re: 3354 Variance request

To: Zoning board of Appeals

John Malvaso and Maureen Murphy
3350 County Rd 16

DRAWING 2
OVERLAY OF REQUEST
WITH BOTH DOOR OPEN
(USING STANDARD 13'0" REFERENCE)

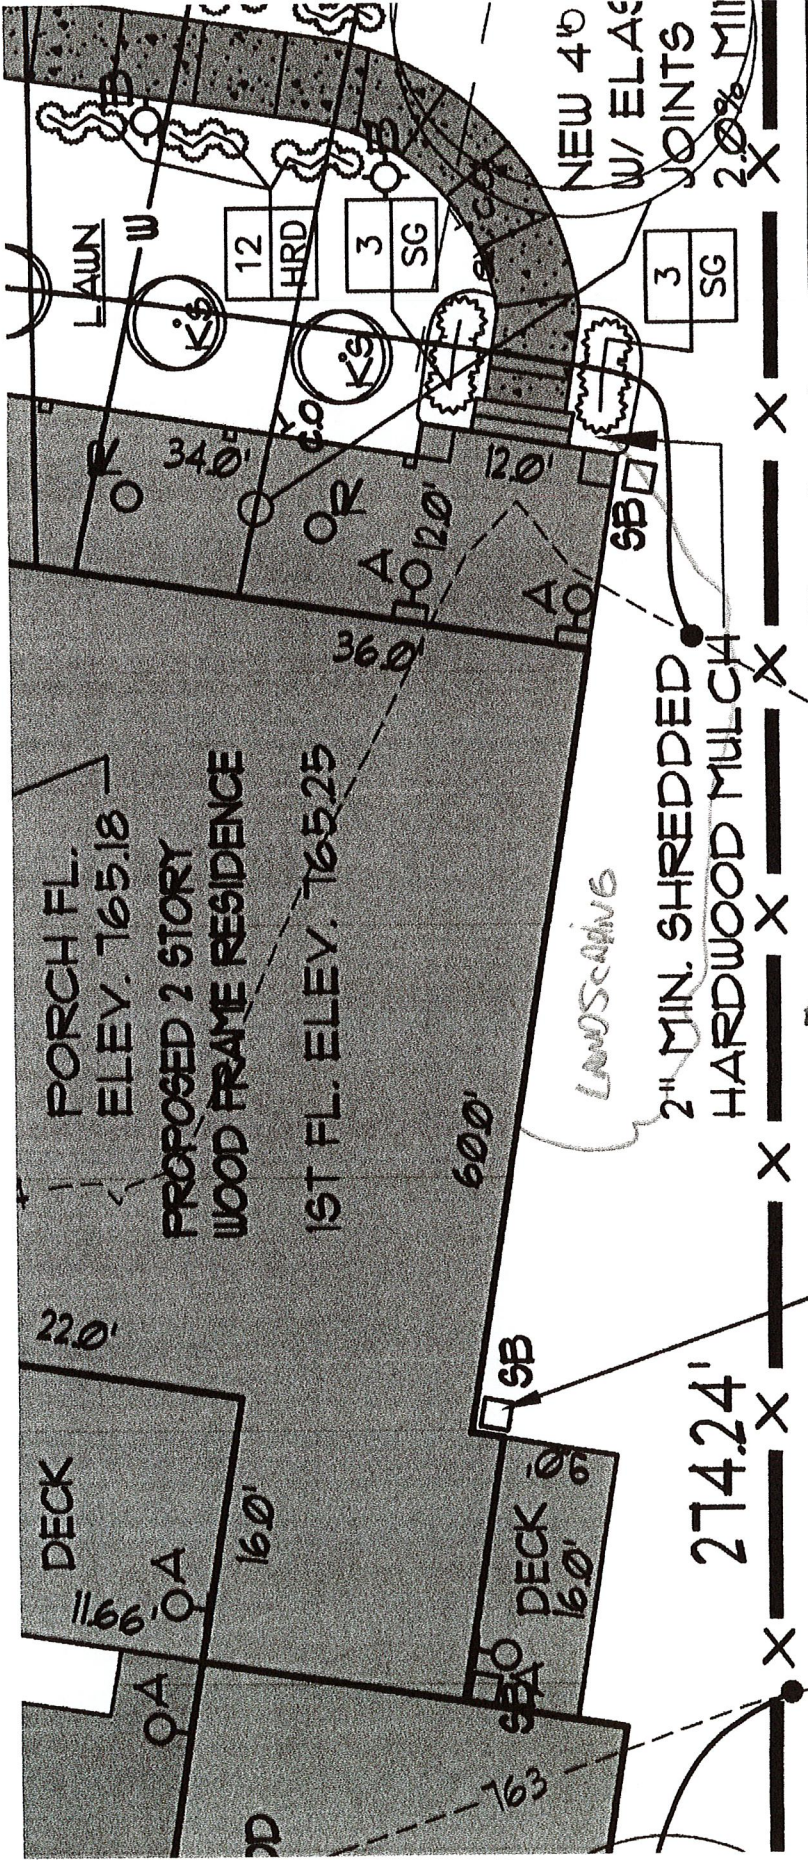
As a matter of actual use-case for the request, I did some research regarding recommended driveway widths with respect to the type of vehicle. For larger vehicles such as trucks the recommended width is 12' minimum. Also, along with that research it was illustrated that a vehicle, such as a truck with both doors open could be as wide as 13' or wider. As a hypothetical situation if there were an existing fence on that lot line the vehicle door could most likely not be fully opened without hitting it. The feasibility of having this proposed driveway is questionable at best.

I have submitted two rough sketches showing an overlay of the setback with the vehicles doors both opened and closed.

FRAME HOUSE
 QUALITY OF REQUEST WITH 18" SERVICE UNITS REQUEST (VEHICLE DOGS CLOSED)

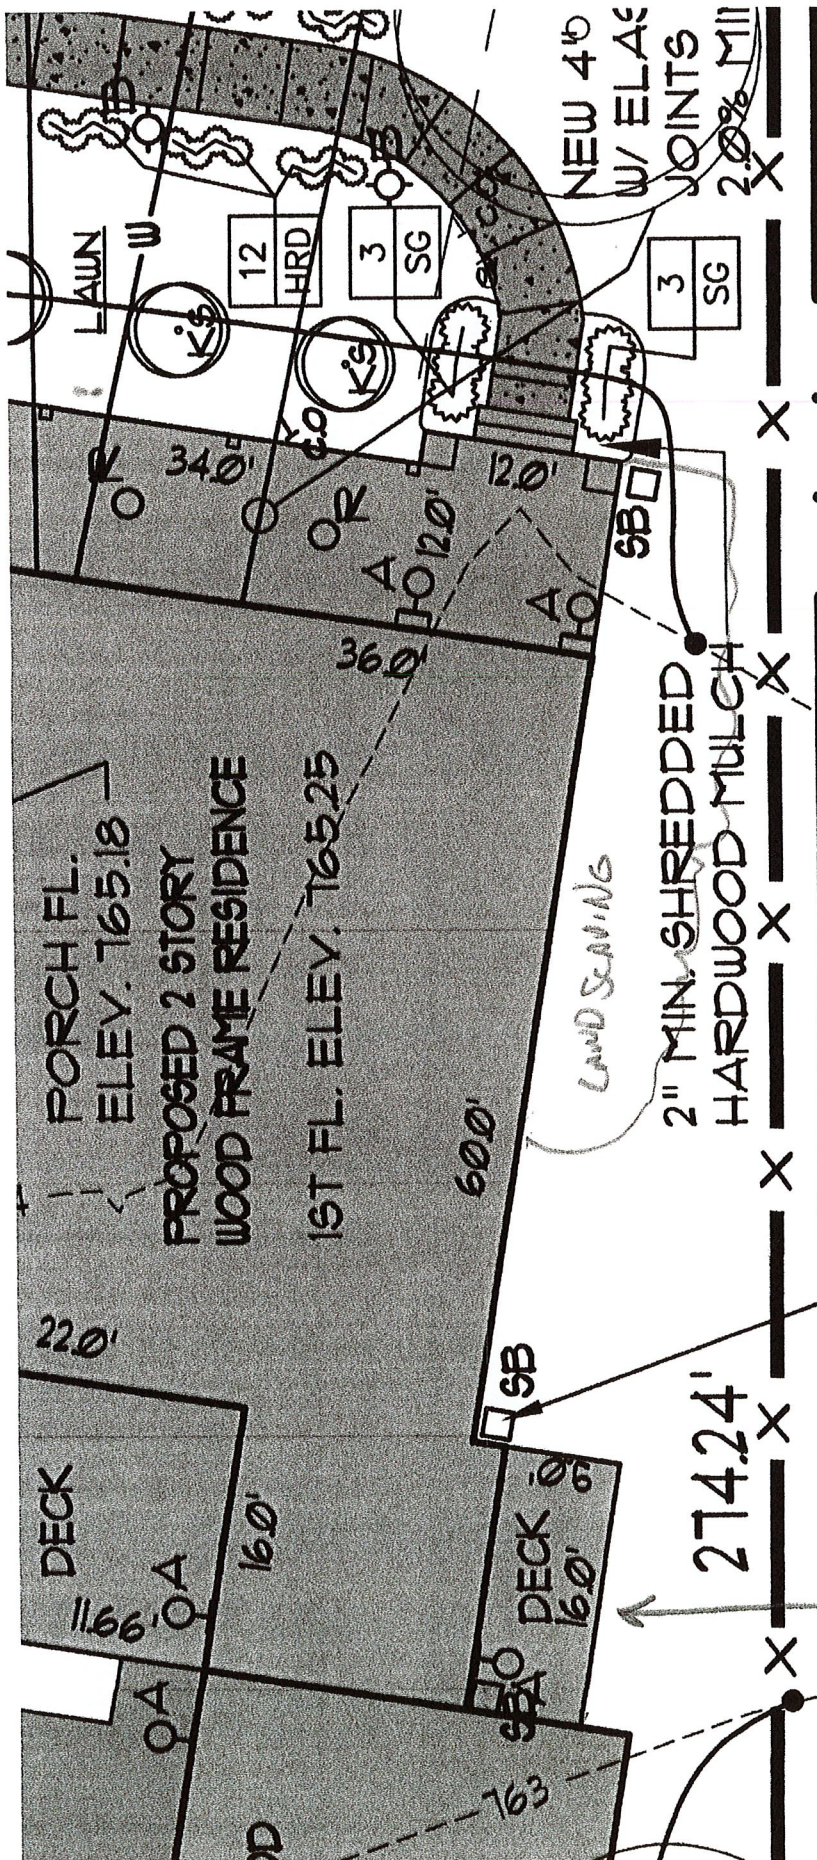
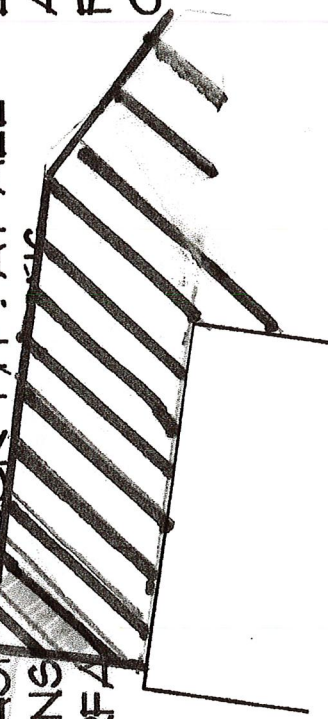
Both issues we have are with respect to the extremely diminished setback requested by Mr. Petroccione. This request calls for a setback variance which reduces the set setback to our home to a mere 18". This setback request is even more exacerbated by the fact that our setback to the lot line in question is about seven feet (7').
